Japan's Comment on the Draft GTR (Dated 25 March 2002) for Installation of Lighting and Light-Signaling Devices

Submitted by the Experts from Japan

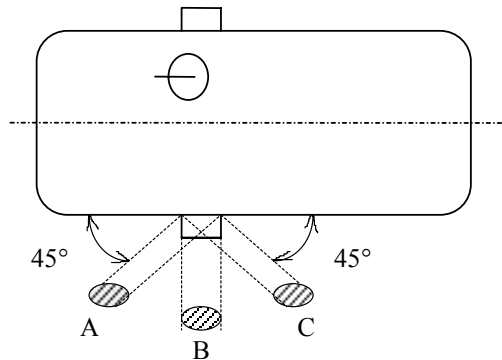
In the 3rd informal GRE Japan was requested to clarify the Japanese visibility measurement method for side direction indicator lamps. The following is our response.

Side direction indicators are measured from 45 degrees rearward, and their measured visible luminous area is required to be at least 10 cm².

In the case of “Middle-side direction indicators”, however, the measurement is performed from 45 degrees forward, from the right angle, and from 45 degrees rearward, and their measured visible luminous area is required to be at least 40 cm² in all of the three directions as shown below.

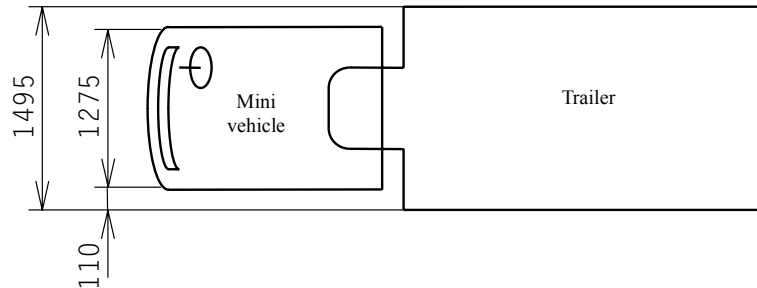
Although Japan previously proposed mandatory installation of front position lamps on all trailers, after in-depth examination Japan modifies its previous proposal and newly proposes "mandatory on trailers over 1,500 mm wide" and "optional on trailers not more than 1,500 mm wide".

There exists a mini vehicle whose overall width is 1,275 mm in Japan. While front position lamp of a trailer is required to be installed not more than 150 mm from the adjacent extreme outer edge of the trailer, we believe that a trailer without front position lamps should not project more than 150 mm outward of its towing vehicle's extreme outer edge.

Assuming a mini vehicle with an overall width of 1,275 mm is to tow a trailer, as the late chairman proposed, the width of the trailer without front position lamps should be less than 1,500 mm. As shown in the figure below, this will put the maximum amount of projection at about 110mm, which, in our opinion, is acceptable.
